# Liveable Neighbourhoods Zone 04 - Gay Street

Stage 3 Road Safety Audit

Project number: 60668625

<b>Report Title:</b>	Liveable Neighbourhoods Zone 04 Gay Street – Stage 3 Road Safety Audit – Designers’ Response
<b>Date:</b>	10 <sup>th</sup> December 2024
<b>Document Reference &amp; Rev:</b>	60668625-ACM-LN04CP-BNESC-RP-RSA3-0001_P01_Designers Response
<b>Prepared by:</b>	██████████, AECOM
<b>On behalf of:</b>	Bath and North East Somerset Council

**SHEET NUMBER**  
60668625-ACM-04-LL\_ETRO-SHT-0102

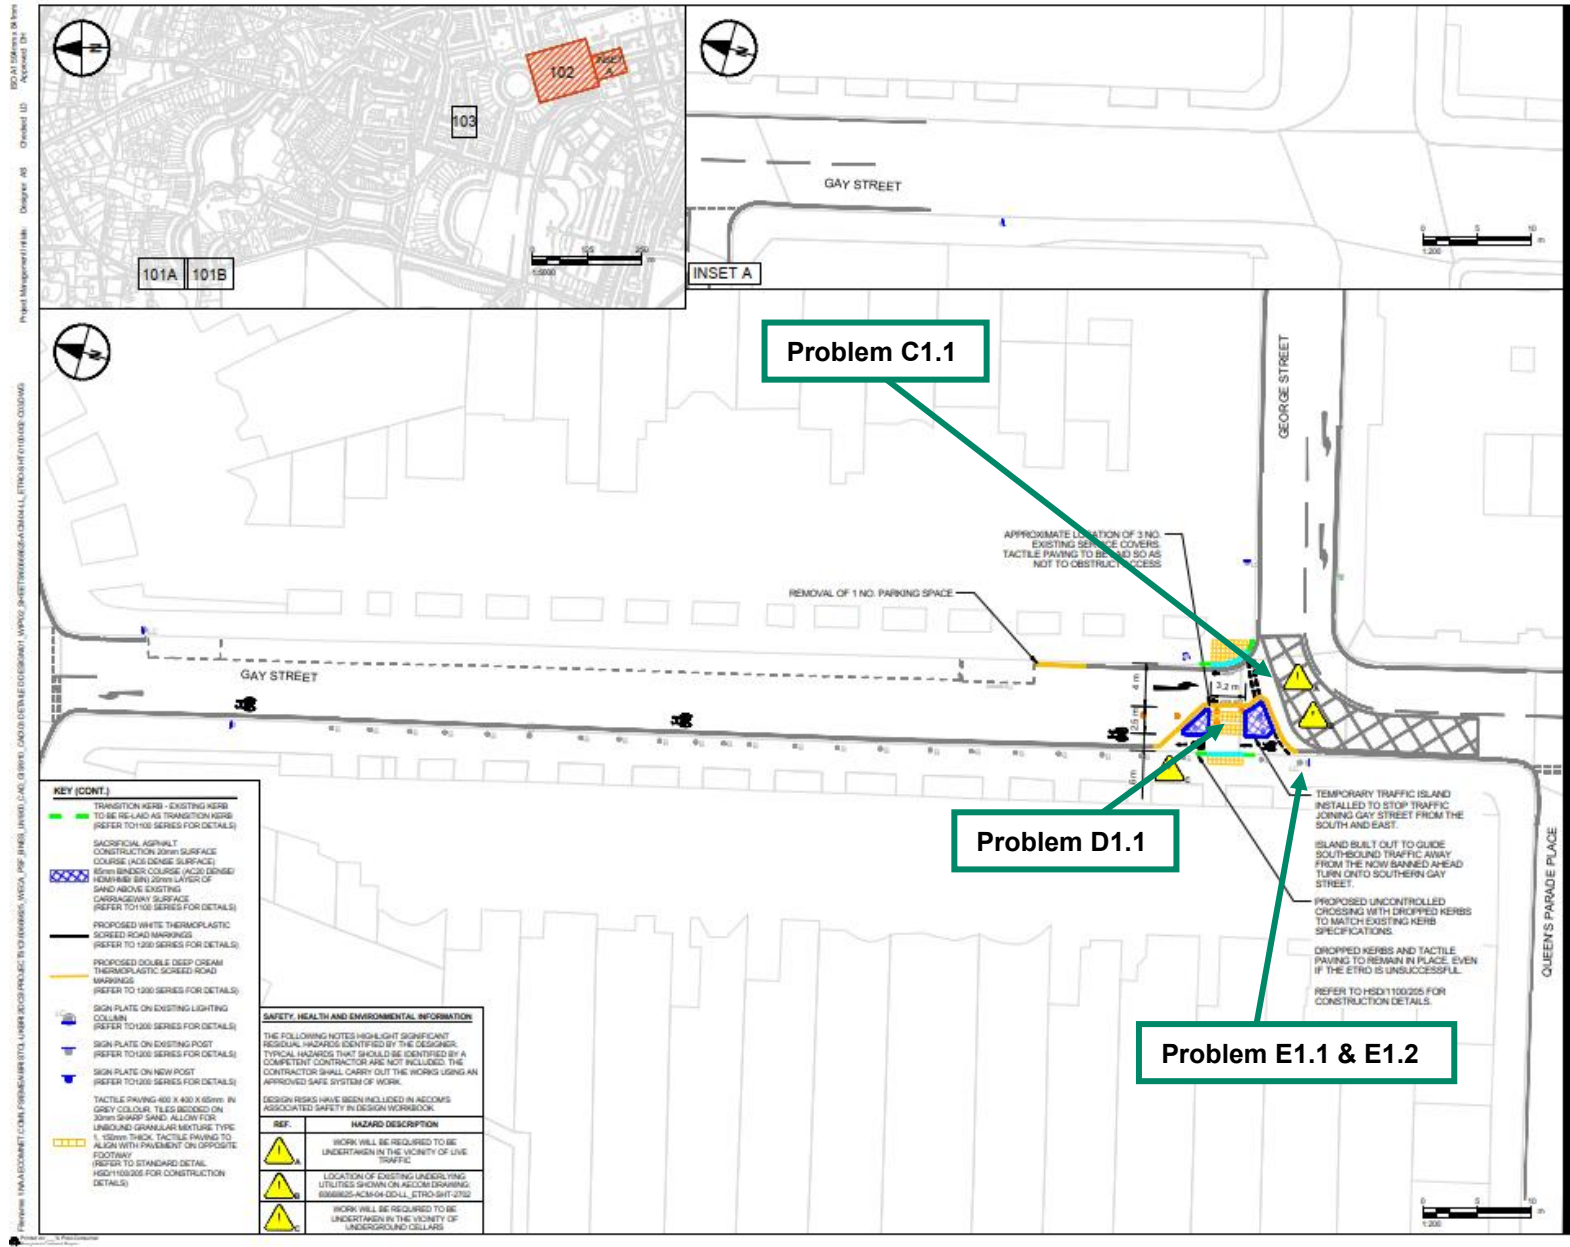
<b>Problem: C1.1</b>	
<b>Drawing Number(s):</b>	60668625-ACM-04-DD-LL_ETRO-SHT-0102.
<b>Location:</b>	Gay Street / George Street junction.
<b>Summary:</b>	Observed banned movements during the site visit may result in a side swipe collision.
<b>Description:</b>	
<p>The scheme has introduced a no entry northbound from Gay Street into Gay Street (which was not prohibited previously) and has also introduced a mandatory left turn for southbound traffic down Gay Street into George Street.</p> <p>However, during the site visit, the Audit Team observed multiple vehicles carrying straight on into Gay Street (southbound) towards Queens Square. Due to the busy nature of George Street, vehicles egressing from Gay Street were observed to edge out of the junction and sit in the middle of the carriageway, waiting for a gap in southbound traffic. If this continues, this may result in a side swipe collision.</p>

<b>Problem: D1.1</b>	
<b>Drawing Number(s):</b>	60668625-ACM-04-DD-LL_ETRO-SHT-0102.
<b>Location:</b>	Tactile paving across Gay Street.
<b>Summary:</b>	Poor installation of tactile paving may result in a trip and fall, causing personal injury.
<b>Description:</b>

<p>The scheme has installed new tactile paving across Gay Street and the modal filter; however, the tactile paving is uneven and has sunk in some places. This uneven and sunken surface creates an upstand in the tactile paving which a pedestrian may trip on and fall, resulting in personal injury.</p> <p>In addition, there are gaps within the tactile paving at the edge of the carriageway. Visually impaired users may reach this gap, and inadvertently continue into the carriageway, increasing their risk of being struck by an oncoming vehicle.</p>	
<b>Recommendation:</b>	
It is recommended that the tactile paving is re-laid flush to the footway without upstand on the kerb and the gap within the paving layout is covered.	
Road Safety Audit Stage 3 Designers Response:	
The tactile paving should be made good by the contractor, ensuring the surface is not uneven and does not present a trip hazard to any users.

<b>Problem: E1.1</b>	
<b>Drawing Number(s):</b>	60668625-ACM-04-DD-LL_ETRO-SHT-0102.
<b>Location:</b>	Gay Street (adjacent to Queens Parade Place).
<b>Summary:</b>	20mph speed limit sign obstructed by signage may result in vehicles exceeding the posted speed limit, resulting in loss of control collisions.

The scheme has installed new signage on an existing post on the northbound carriageway of Gay Street. However, this signage obstructs an existing 20mph speed limit sign. Drivers may fail to observe the posted speed limit of 20mph, and travel at a higher speed, resulting in a loss of control collision.

<b>Problem: E1.2</b>	
<b>Drawing Number(s):</b>	60668625-ACM-04-DD-LL_ETRO-SHT-0102.
<b>Location:</b>	Gay Street (adjacent to Queens Parade Place).
<b>Summary:</b>	Information on signage may confuse motorists, resulting in unsuitable manoeuvres and cause rear end shunt or graze type collisions.
<b>Description:</b>

<p>The scheme prevents northbound vehicular access to Gay Street with the installation of a modal filter and “no entry” signs. However, an existing sign stating “except authorised buses” may cause confusion for motorists and/or bus drivers, as they may believe buses are able to travel northbound along Gay Street which is not possible due to the new alignment of the modal filter. This may result in unsuitable and sudden manoeuvres, causing graze type or rear end shunt collisions.</p>	
<b>Recommendation:</b>	
It is recommended the bus signage is removed.	
<b>Road Safety Audit Stage 3 Designers Response:</b>	
<p>The ‘For Construction’ drawings issued to the contractor showed the ‘Except authorised buses’ signage and supplementary plate to be removed and stored off site.</p> <p>This should be resolved as snagging by the contractor.</p>	
<b>Road Safety Audit Stage 3 Overseeing Organisation Response:</b>

<b>Recommendation:</b>	
It is recommended that the junction is monitored and drivers undertaking banned movements are educated.	
Road Safety Audit Stage 3 Designers Response:	
Monitoring of the junction will be undertaken as part of the ETRO process. Discussions are being undertaken by the Highway Authority around the use of education and camera enforcement for heading south bound on Gay Street and turning east into George Street.	
Road Safety Audit Stage 3 overseeing Organisation Response:	
Agree with recommendation and Designers Response.

Where the tactile paving is obstructed by a utility cover, temporary tactile paving secured with adhesive, in a matching colour, should be used to fill in the gap.	
Road Safety Audit Stage 3 Overseeing Organisation Response:	
Agree that tactile paving should be made good and if practical, added in the gap between the utility cover and paving.

It is recommended that the 20mph speed limit sign is relocated into full visibility to drivers of approaching vehicles.

The signage referred to in the picture was not installed by the scheme and is existing signage that should have been removed in accordance with the 'For Construction' drawing.

When the signage is removed, as per the design, the 20mph sign should be visible to drivers.

Agree with recommendation and Designers response.

Agree with recommendation and Designers response.
